project: **SOP 53 2** FIGTREE DRIVE <u>SYDNEY OLYMPIC PARK</u> Copyright of the design and other information shown here is owned by Mirvac Design pty. Itd. Reproduction or use of the design by any party for any purpose is expressly forbidden without the written permission of Mirvac Design pty. Itd. Mirvac Design Nominated Architect Diana Sarcasmo NSW: 6525, VIC:19056, OLD: 5091, WA: 2982

# COVER SHEET

Modification to SSD 7662

### MODIFICATION TO SSD 7662

drawing no: DA-2133 rev: K

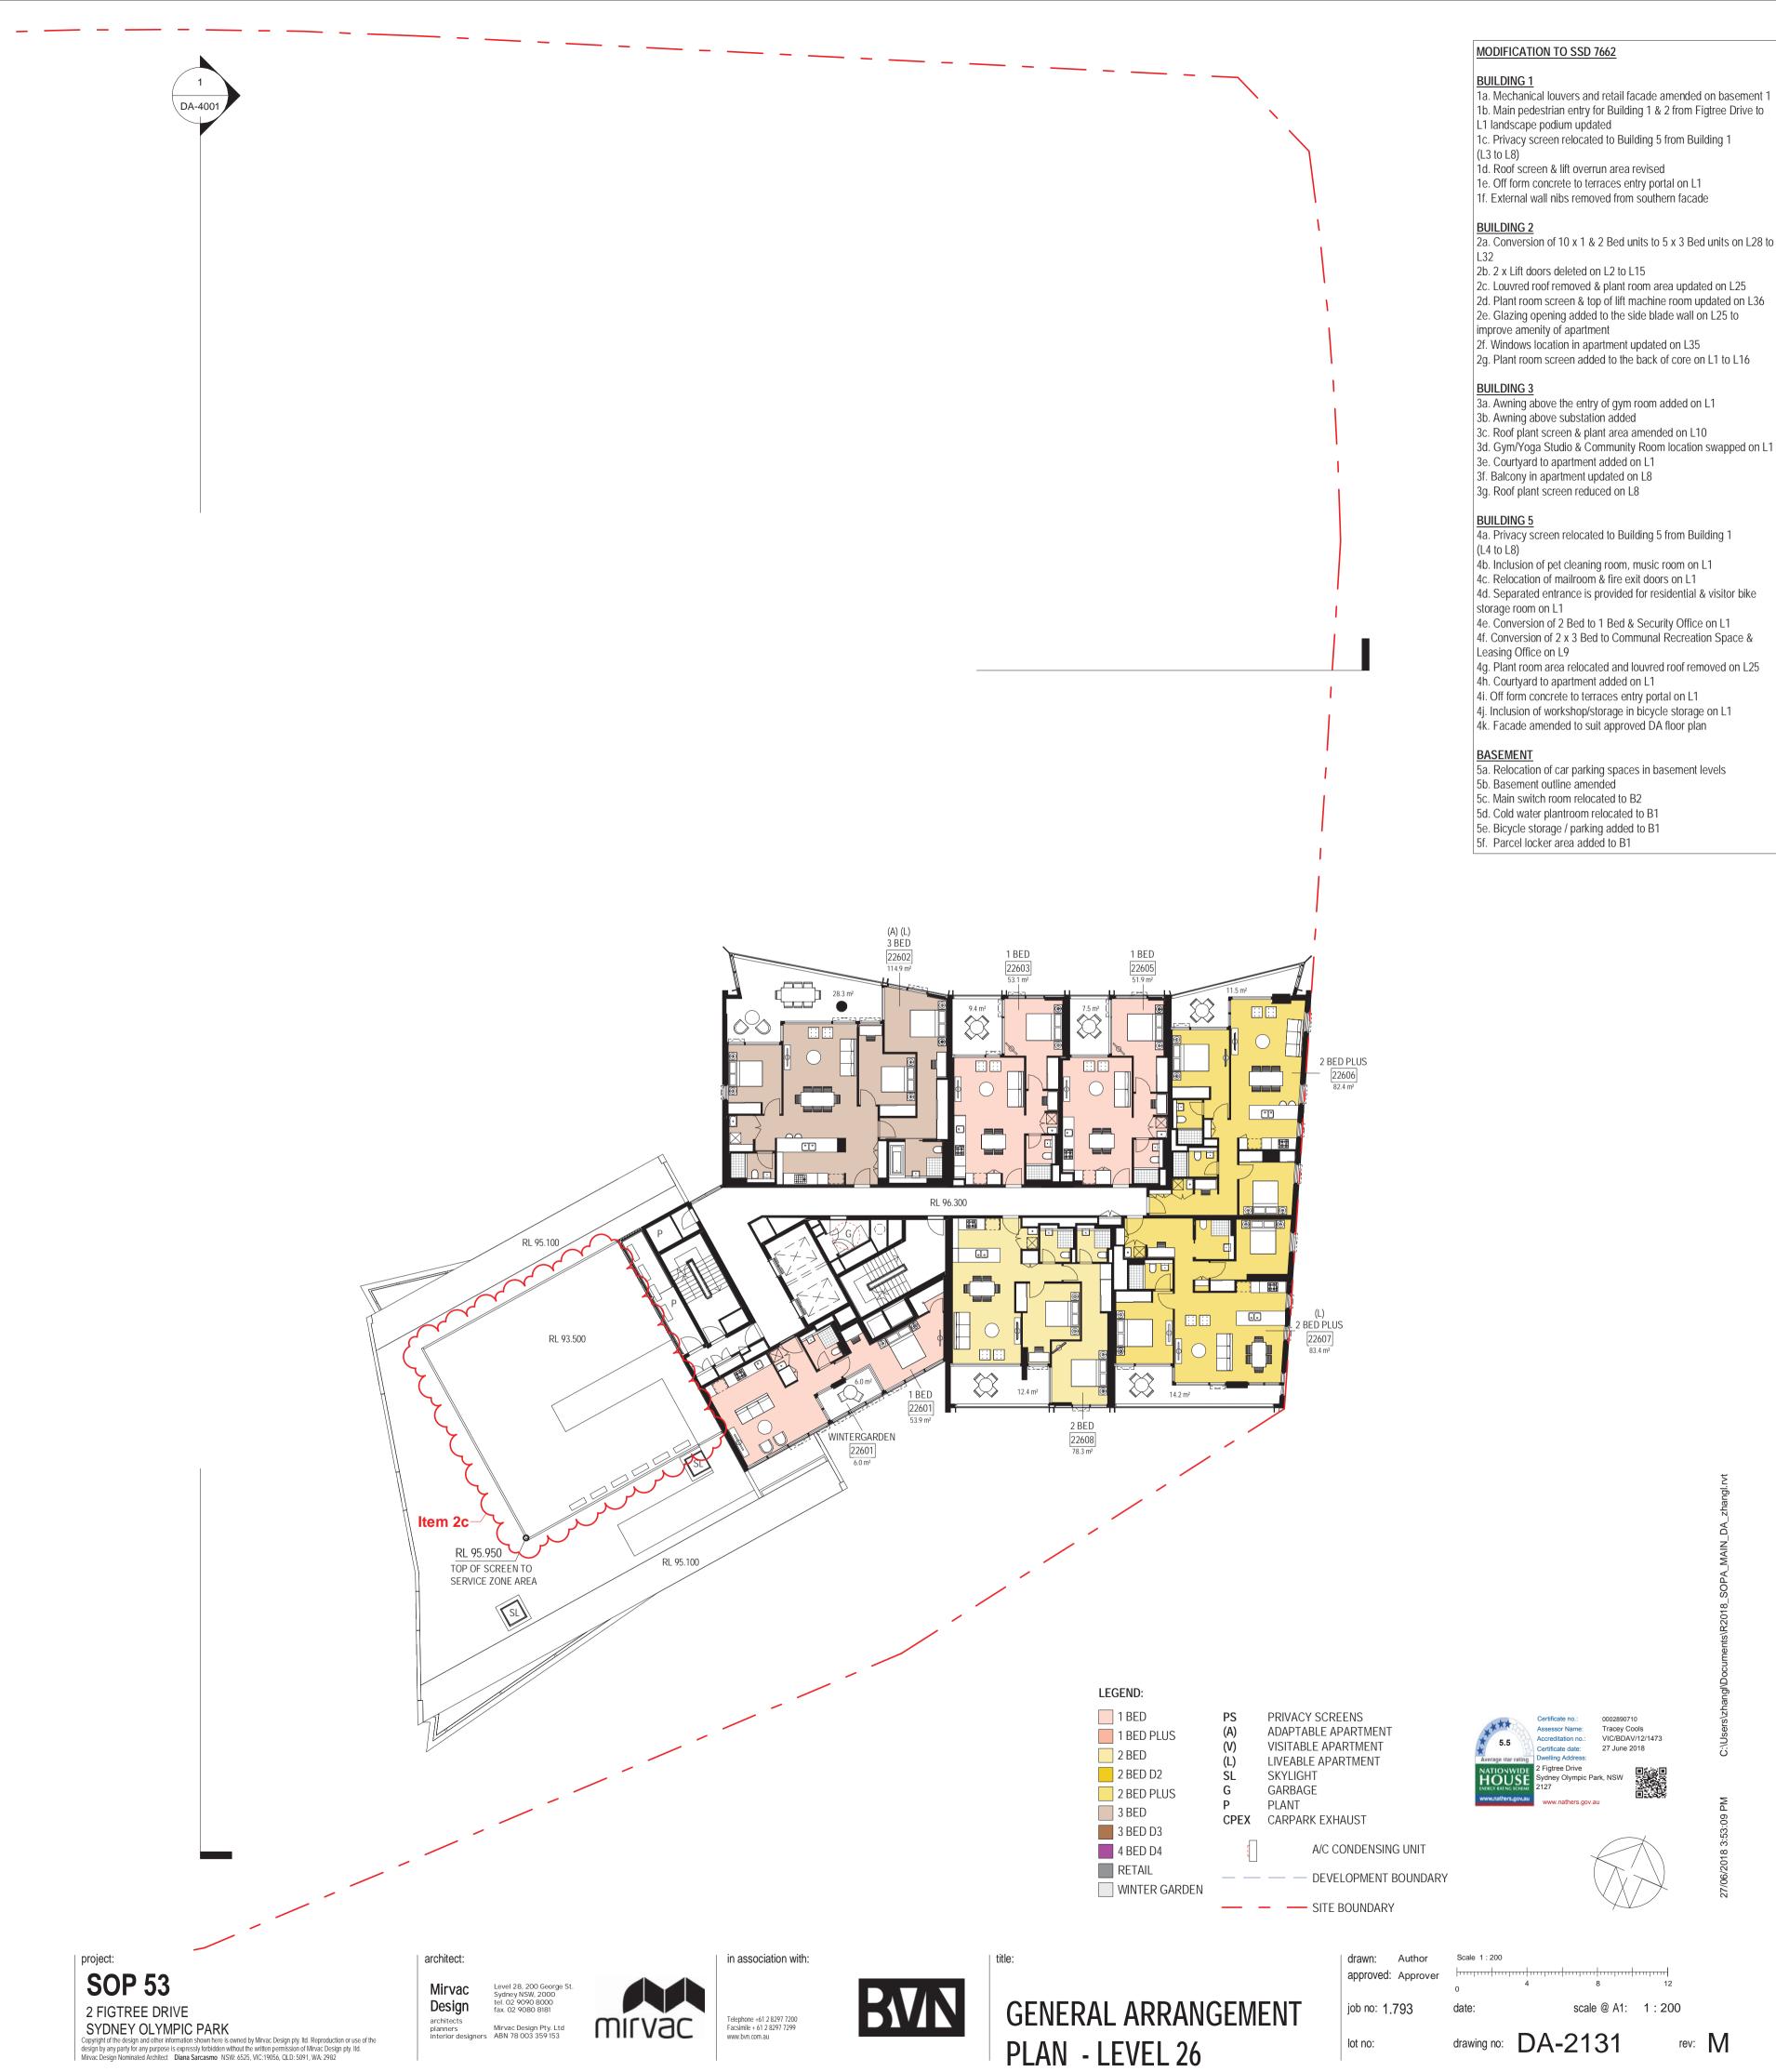
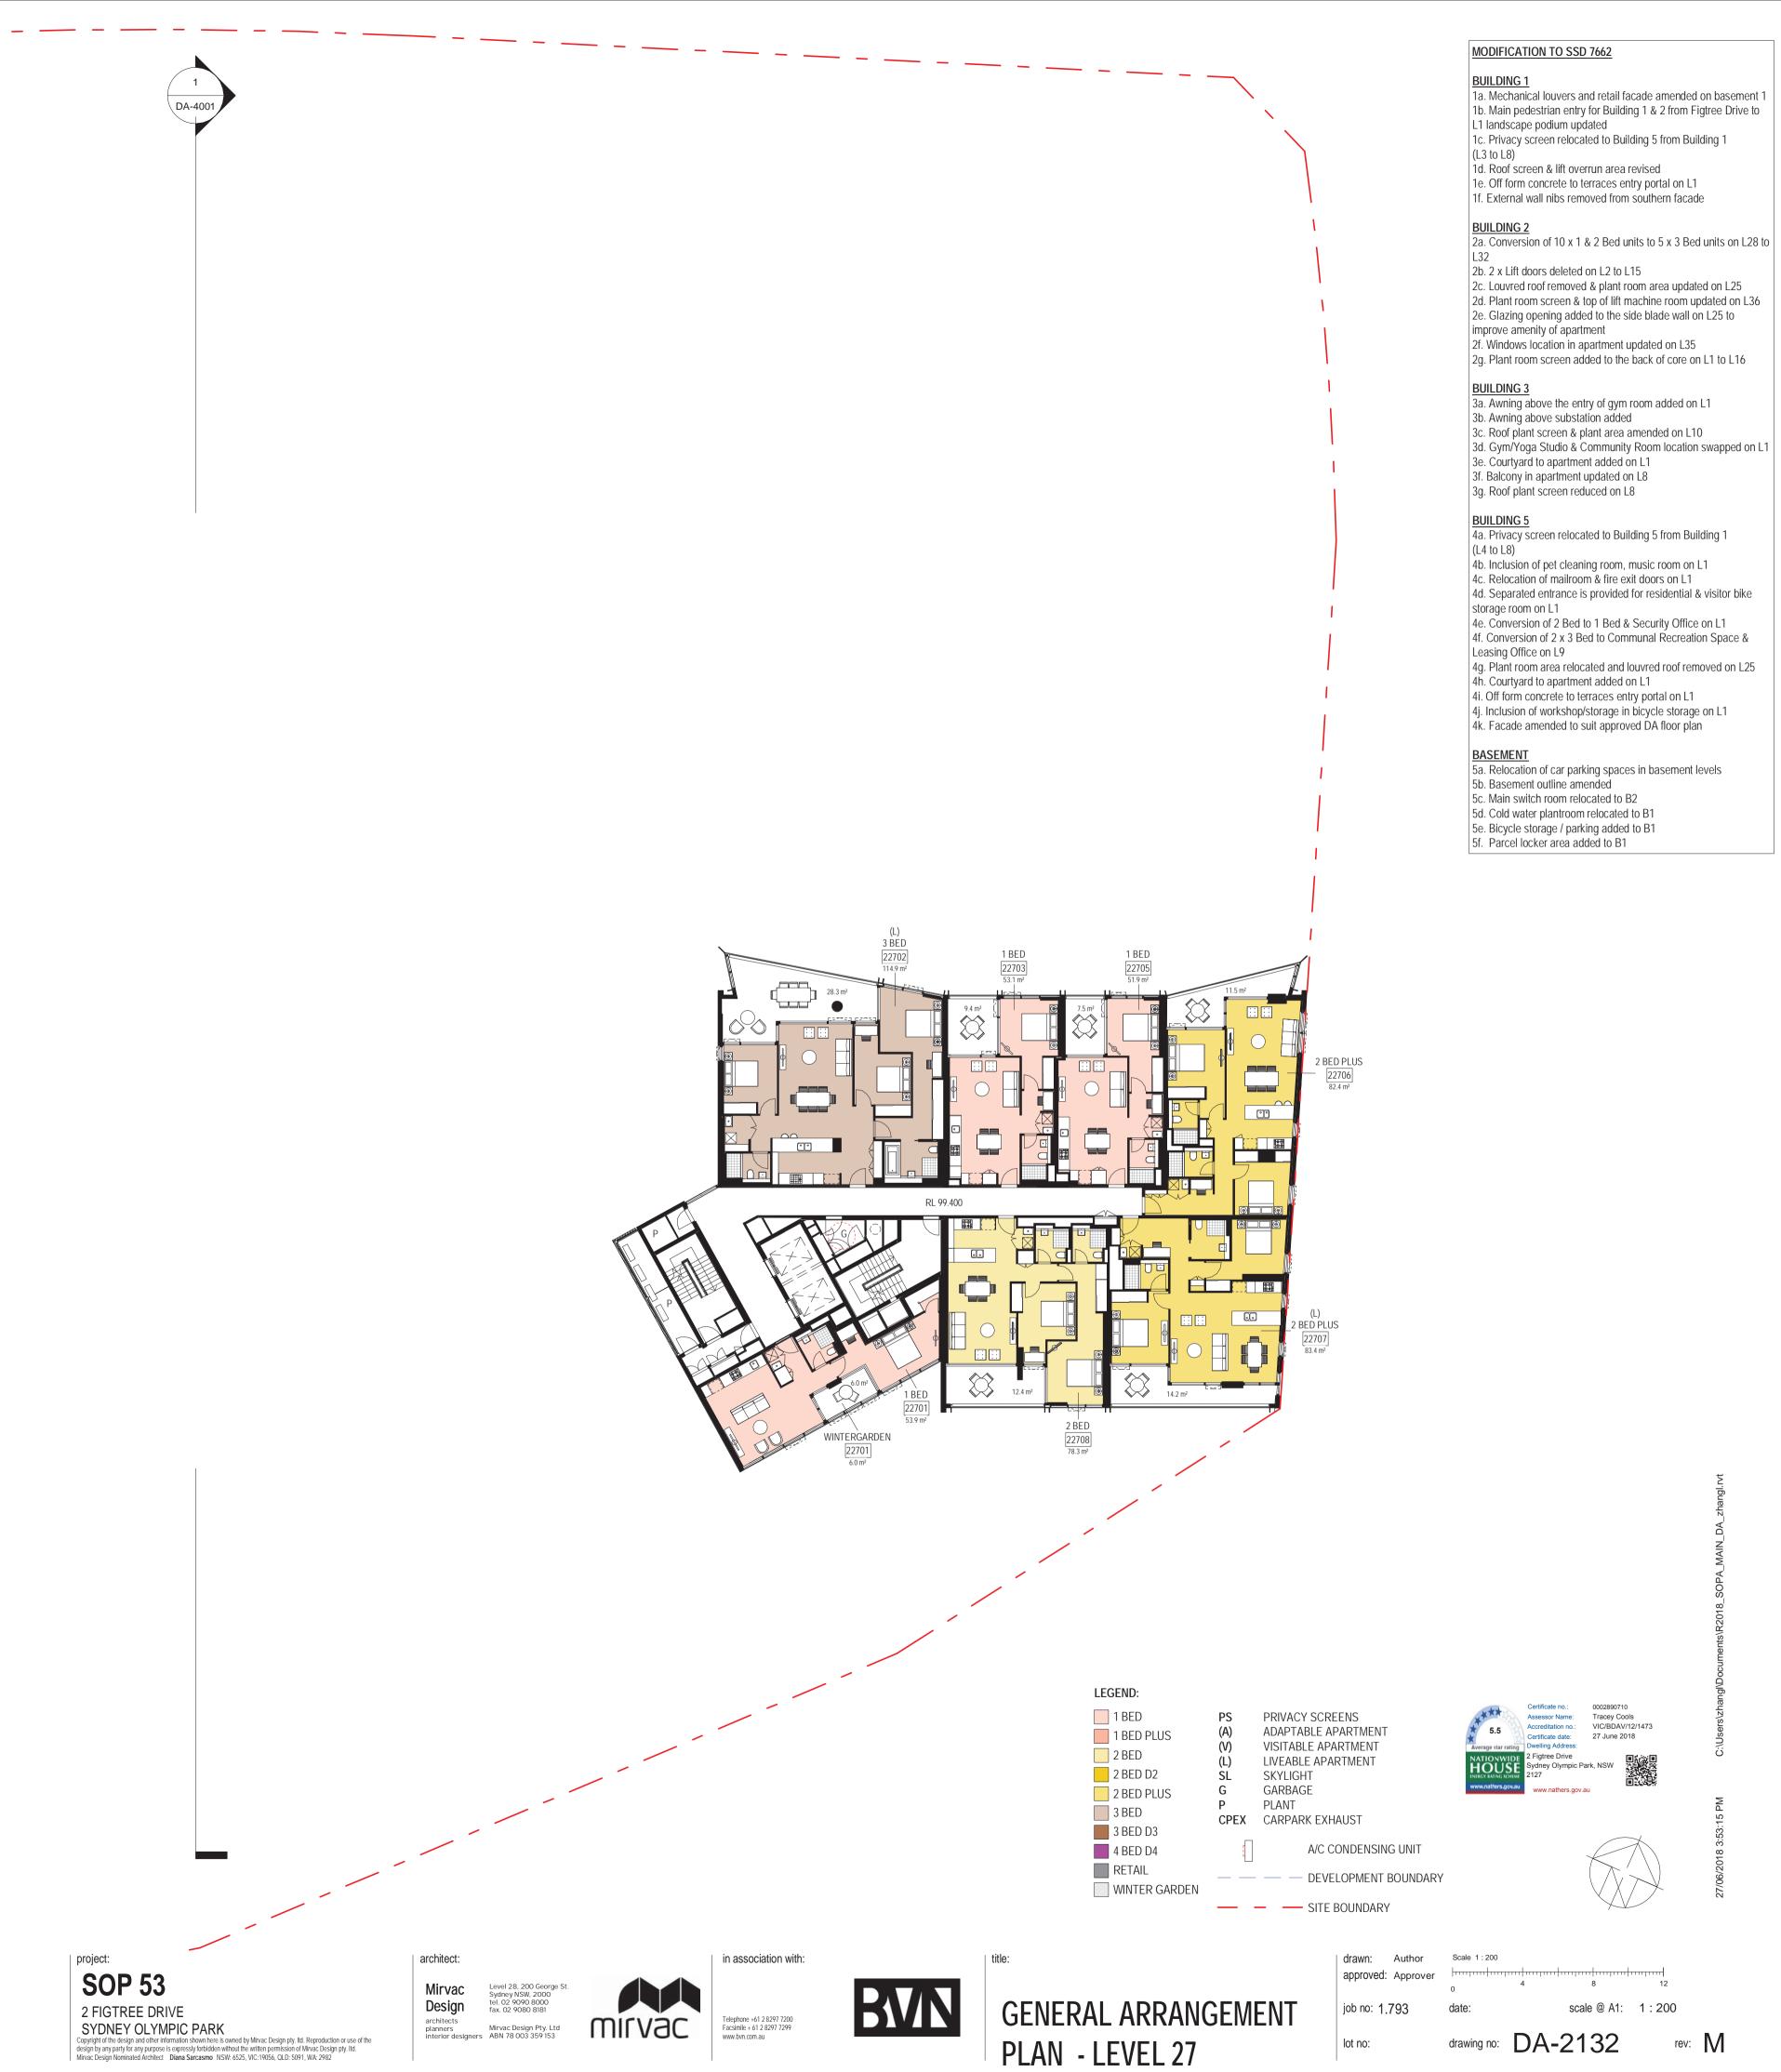
- 1a. Mechanical louvers and retail facade amended on basement 1 1b. Main pedestrian entry for Building 1 & 2 from Figtree Drive to
- L1 landscape podium updated
- 1c. Privacy screen relocated to Building 5 from Building 1 (L3 to L8)
- 1d. Roof screen & lift overrun area revised
- 1e. Off form concrete to terraces entry portal on L1
- 1f. External wall nibs removed from southern facade

2c. Louvred roof removed & plant room area updated on L25 2d. Plant room screen & top of lift machine room updated on L36

- 2e. Glazing opening added to the side blade wall on L25 to improve amenity of apartment
- 2f. Windows location in apartment updated on L35

2g. Plant room screen added to the back of core on L1 to L16

- 3a. Awning above the entry of gym room added on L1 3b. Awning above substation added
- 3c. Roof plant screen & plant area amended on L10
- 3d. Gym/Yoga Studio & Community Room location swapped on L1
- 3e. Courtyard to apartment added on L1
- 3f. Balcony in apartment updated on L8 3g. Roof plant screen reduced on L8

4g. Plant room area relocated and louvred roof removed on L25 4h. Courtyard to apartment added on L1

- 4i. Off form concrete to terraces entry portal on L1
- 4j. Inclusion of workshop/storage in bicycle storage on L1
- 4k. Facade amended to suit approved DA floor plan
